Craig 4351 Service Bulletin# 102775

*SB: 102775
October 27, 1975

TO: ALL AUTHORIZED WARRANTY SERVICE CENTERS
FROM: LARRY TINKLER, NATIONAL SERVICE MANAGER
SUBJECT:MODIFICATION OF 4351 POCKET SCANNER.....

GRATIC MODEL 4351
 SCHEMATIC DIAGRAM

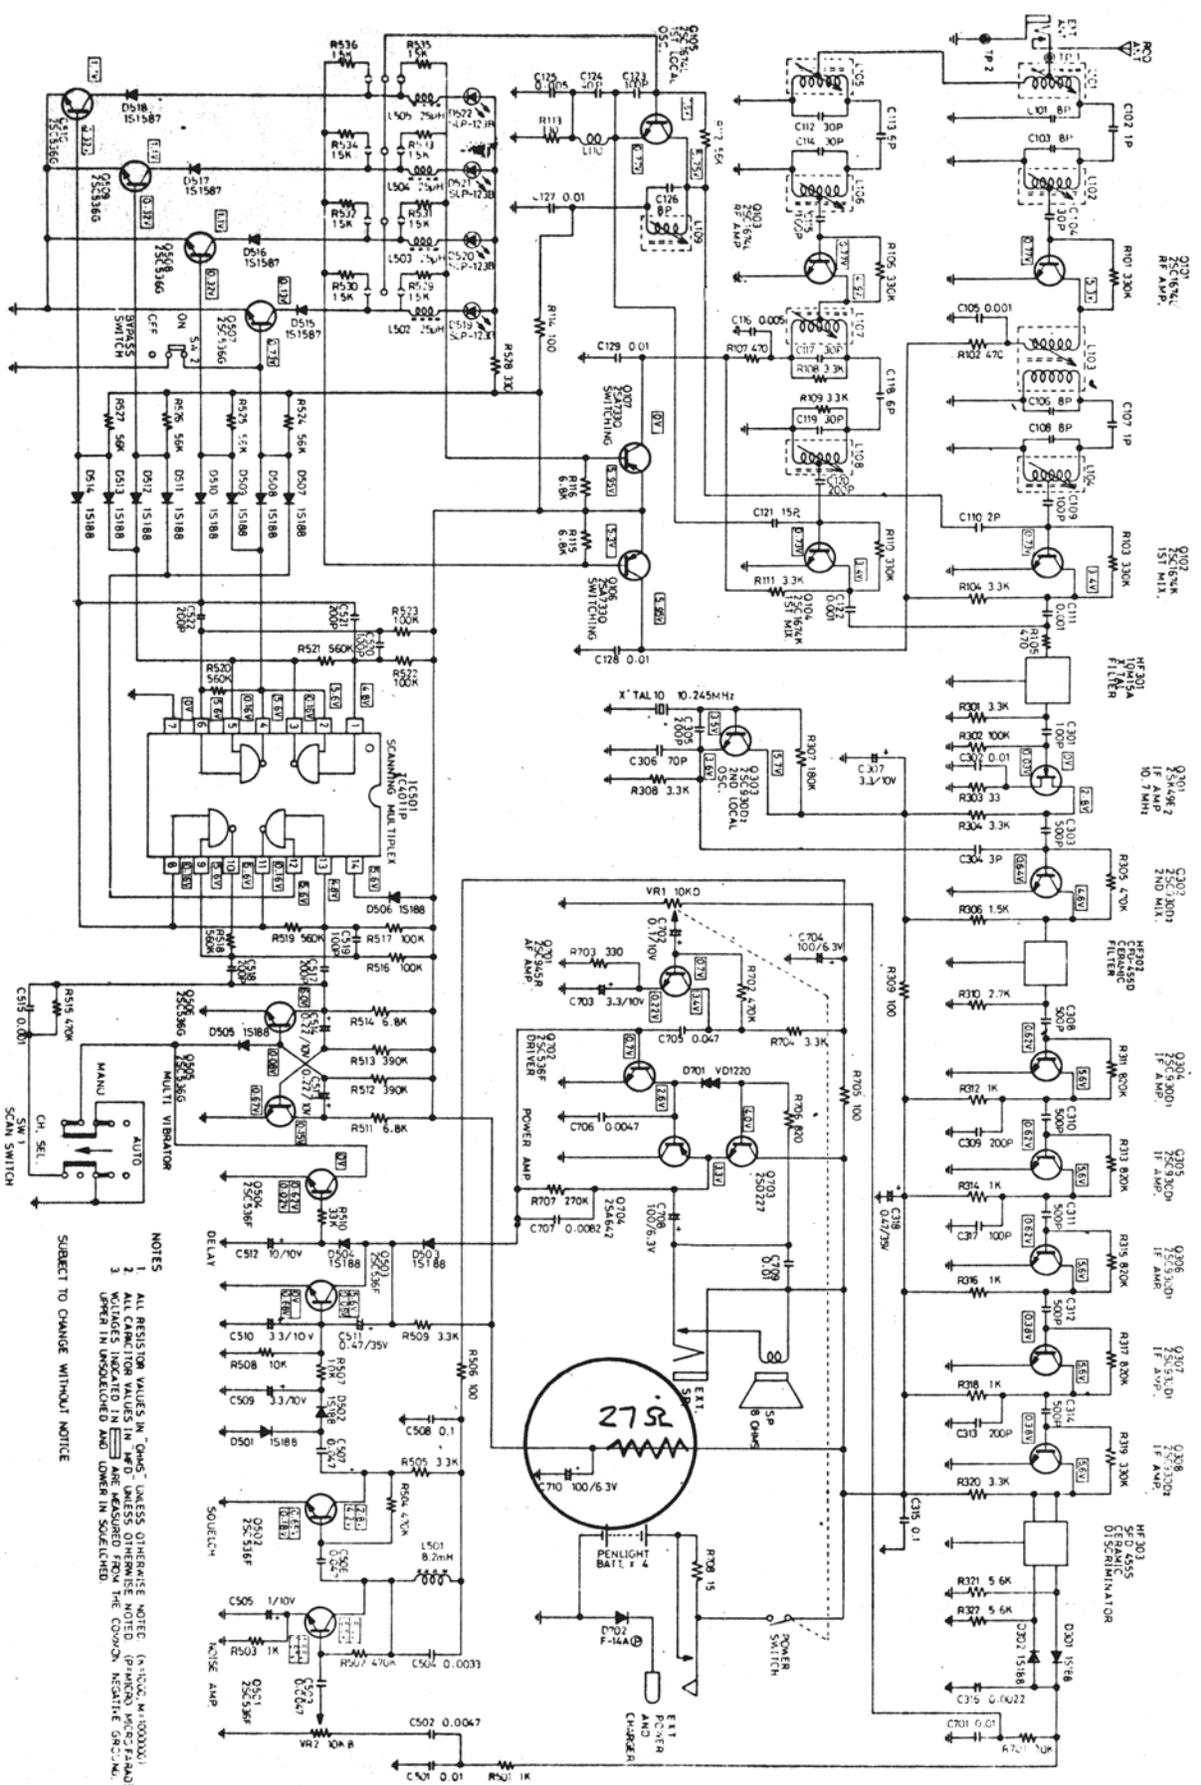
PROBLEM: Irratic scanning when using 9227 A.C. Adapter, — OK on batteries.

1. Cut the red wire attached to the on/off power switch nearest unit front at the power switch. This wire attached to P.C.B. near Xtal sockets.
2. Solder a 27 Ohm $\frac{1}{2}$ W. Resistor between cut red lead and switch terminal in Step #1.
3. Locate another red wire which connects to P.C.B. at the end of a row of glass diodes in center of P.C.B. adjacent to Xtal sockets. Cut this wire and solder to same power switch terminal described in Steps #1 and 2. (See reverse side).

27OHM

CUT RED WIRE
STEP #3 AT THIS
POINT

CURE: Use Craig 9221 Adapter or add 27 Ohm Resistor as shown.
